Planning and Zoning Commission

March 5, 2019

Mustang Ridge Plat 1 – Preliminary Plat

Communication Data Link – Site Plan
Grimes Industrial Park – Parcel 2018-10 of Lot 11
1255 SW 37th Street
FOX P.N. 8630-04F.284

LANDSCAPE PLAN

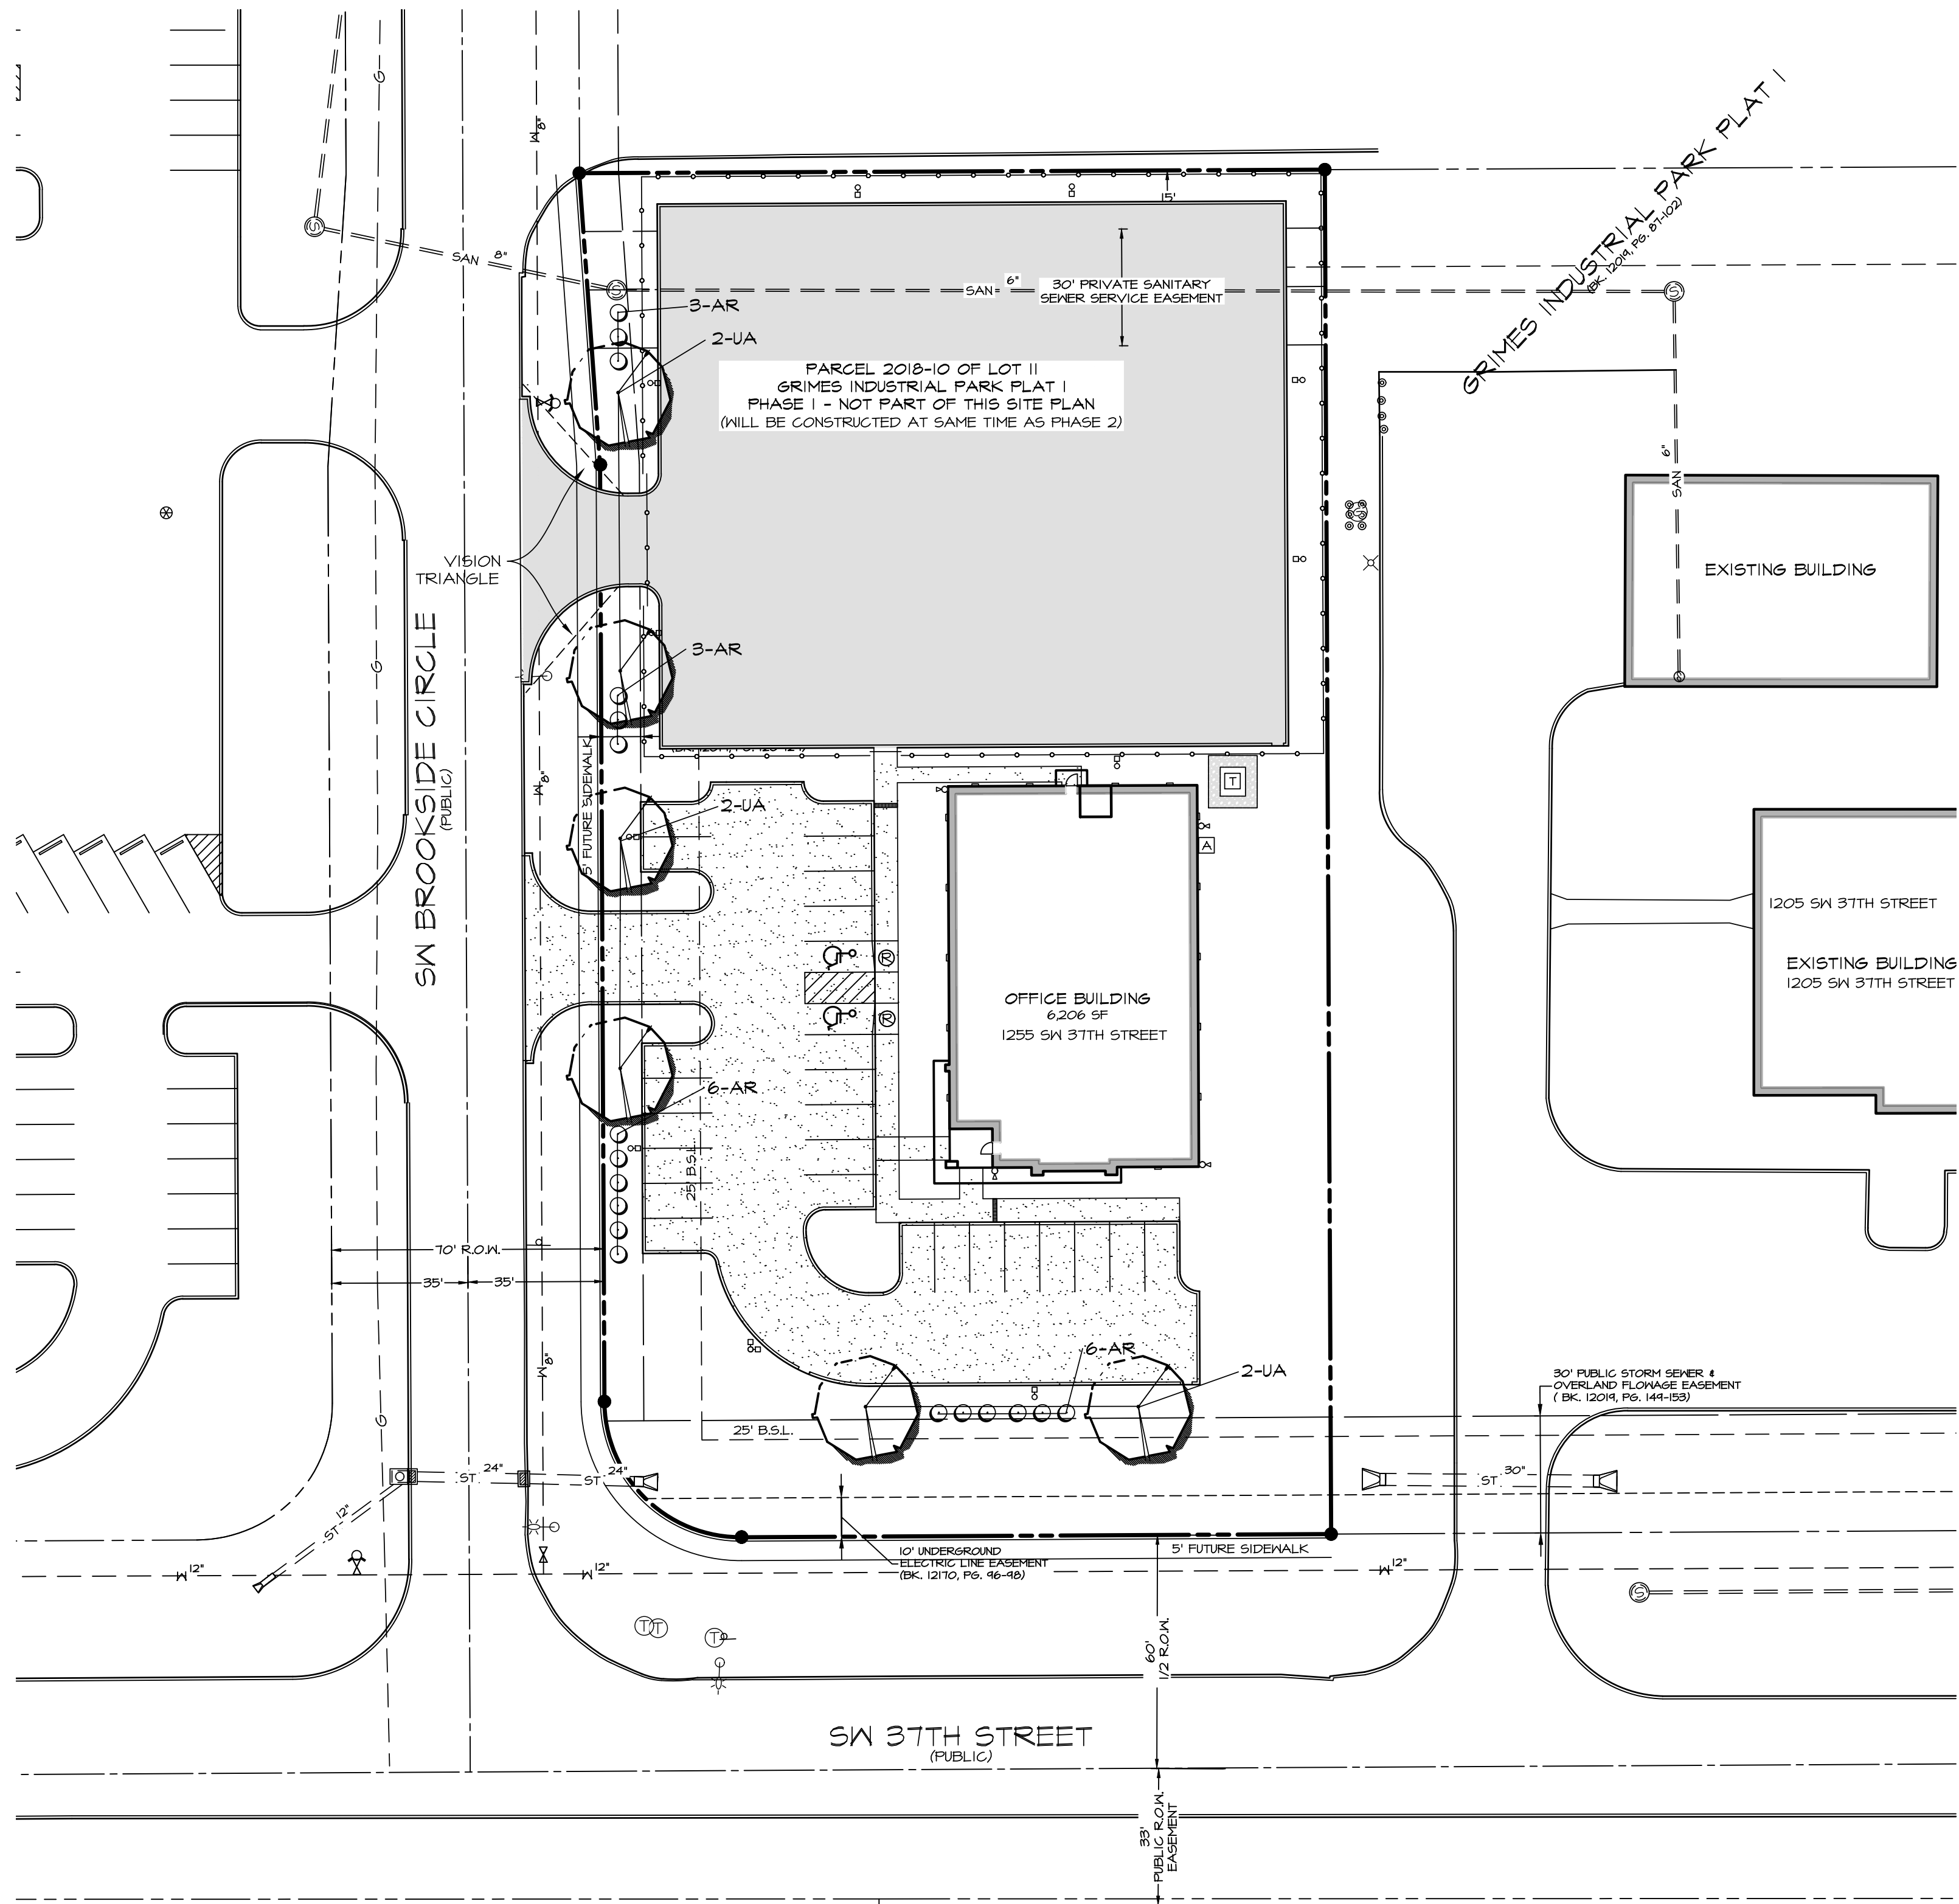
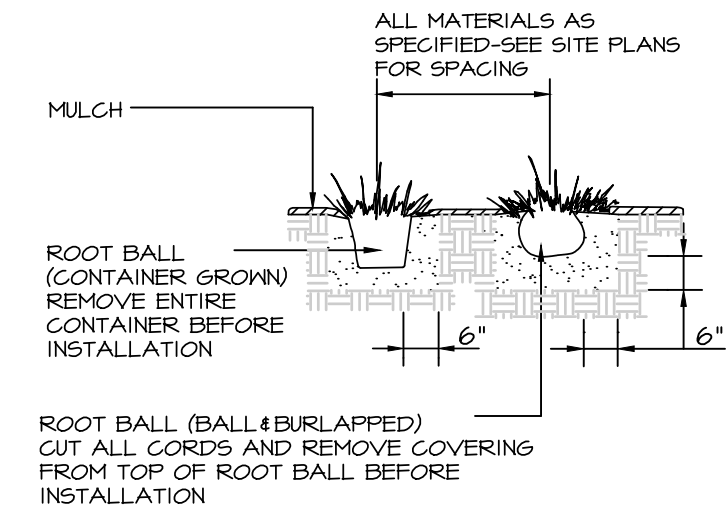
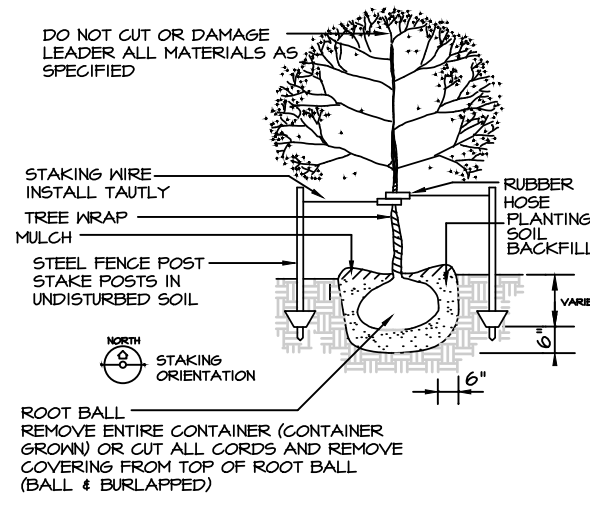
3. Please provide screening of mechanical units from right of way (165.51, 3, A (2))
